Tennessee Valley Authority, 1101 Market Street, Chattanooga, Tennessee 37402-2801

Watts Bar Nuclear Plant, Unit 1
Facility Operating License No. NPF-90
NRC Docket No. 50-390

Subject: **License Amendment Request and Response to Request for
Additional Information Related to Carbon Dioxide Fire
Suppression System (TAC No. ME0876)**

License Amendment Request and Response to
Request for Additional Information Related to
Carbon Dioxide Fire Suppression Systems

Figure 1 – Sandia Test #83 CO₂ Concentration Results

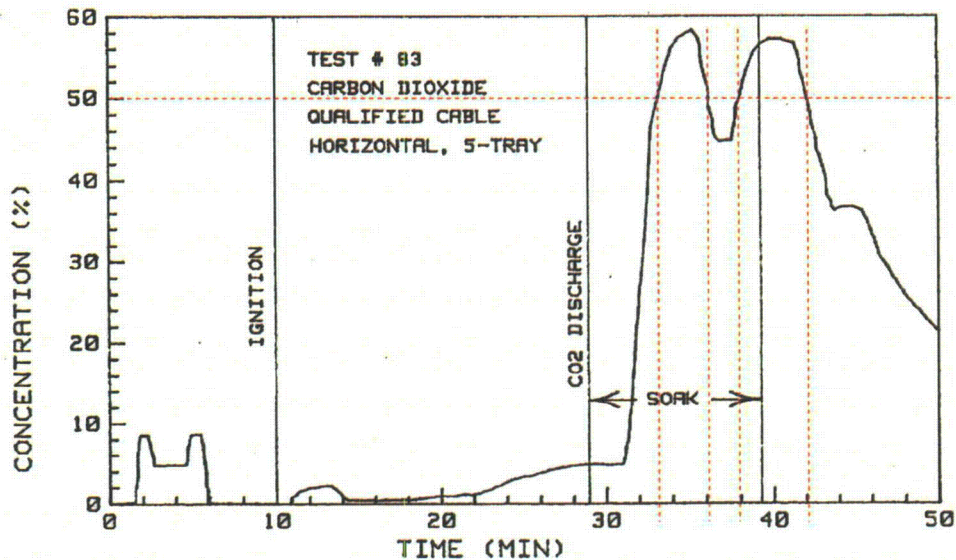
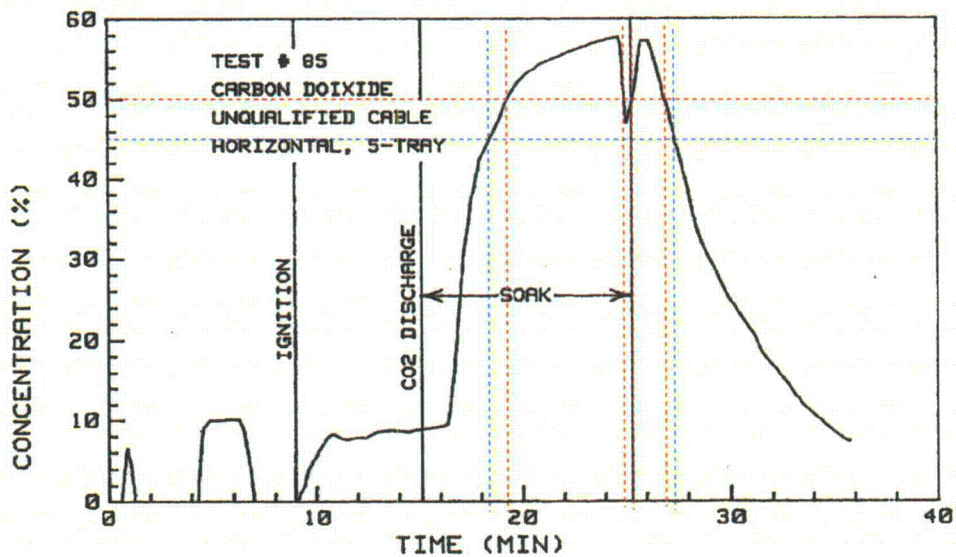
Provide a basis for why you believe it is adequate for the total flooding automatic CO₂ fire suppression system installed in the Auxiliary Instrument Room to achieve a concentration of only 45 percent (rather than at least 50 percent) for 15 minutes in the upper portion.

TVA Figures 1 and 2 (Sandia Figures 36 and 37, respectively) show CO₂ concentration as a function of time for Sandia Tests #83 and #85. In Sandia Test #83 (Qualified Cables), the total time that CO₂ concentration was at or

above 50% was approximately 7 minutes – for approximately 3 minutes following the initial discharge and for approximately 4 minutes following the second discharge. The concentration was below 50% for almost 2 minutes before the second discharge returned the concentration to above 50%. For Sandia Test #85 (Unqualified Cables), the total time that the CO₂ concentration was at or above 50% was approximately 8 minutes – for approximately 6 minutes following the initial discharge and for approximately 2 minutes following the second discharge. The concentration was below 50% for slightly less than one minute before the second discharge returned the concentration to above 50%.

WBN Fire Protection Report
Figure II-33
TVA DWG No. 47W240-6 R8

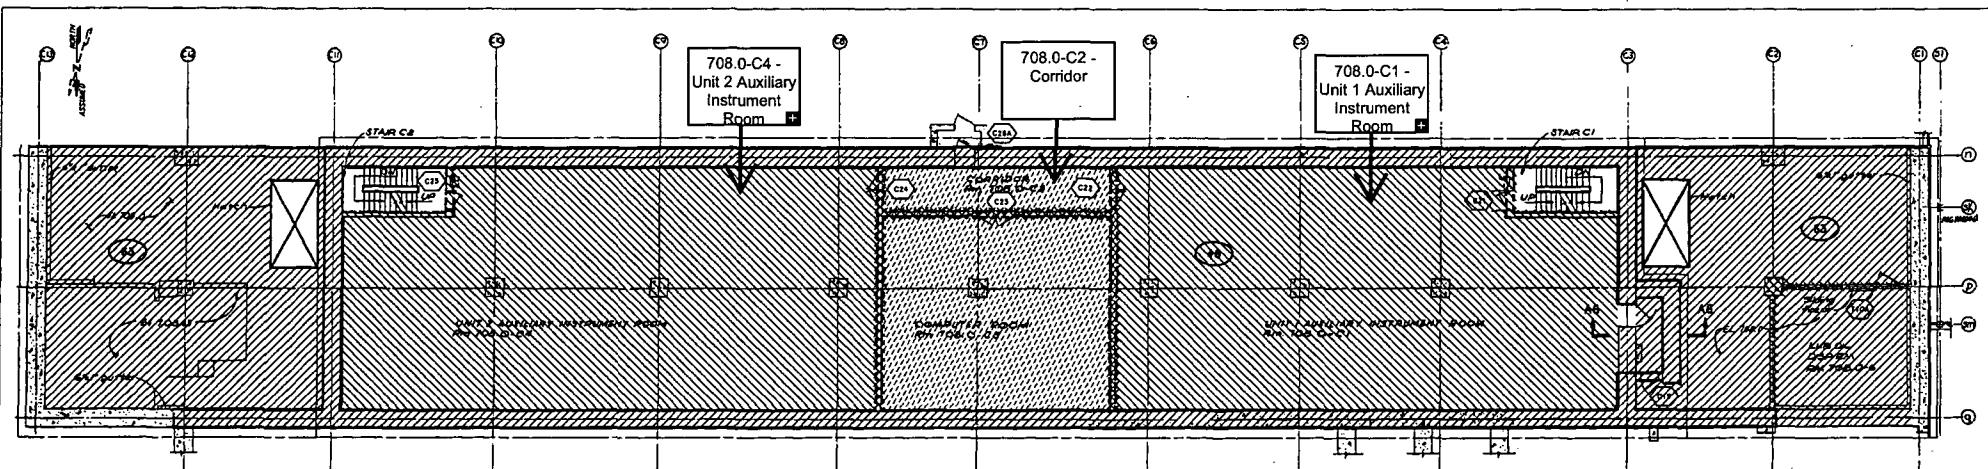
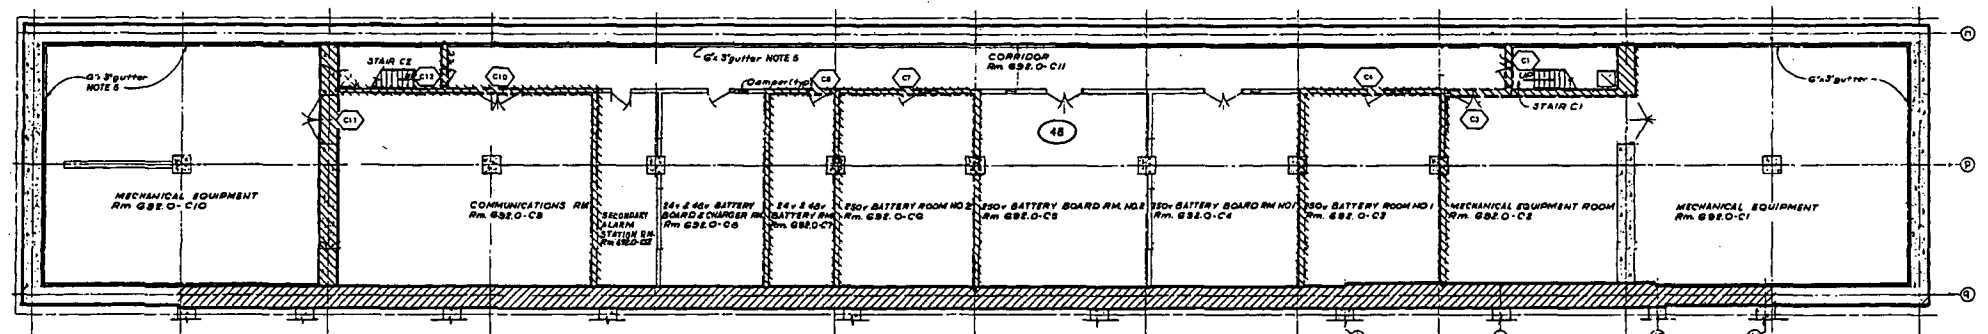
Confirm that there are no ignition sources other than two air handling units in this fire area. Provide a summary and the results of the "Zone of Influence" calculations.

Figure II-33 of the FPR is provided in Attachment 6 to this enclosure and depicts the layout of the Auxiliary Instrument Room. This figure is annotated and provided with notes to clarify which walls are considered regulatory fire barriers. Based on Figure II-33, the walls of the Auxiliary Instrument Room that are regulatory fire barriers are inspected once every 5 years in accordance with 0-FOR-304-1, "Fire Barrier/Mechanical, Conduit, Cable Tray, and Fire Damper (External) Penetration Visual Inspection-Auxiliary, Control, Diesel Generator Buildings and Intake Pumping Station" include:

As stated previously, Figure II-33 is provided as Attachment 6 to this enclosure. The figure has been annotated to clearly designate the following rooms:
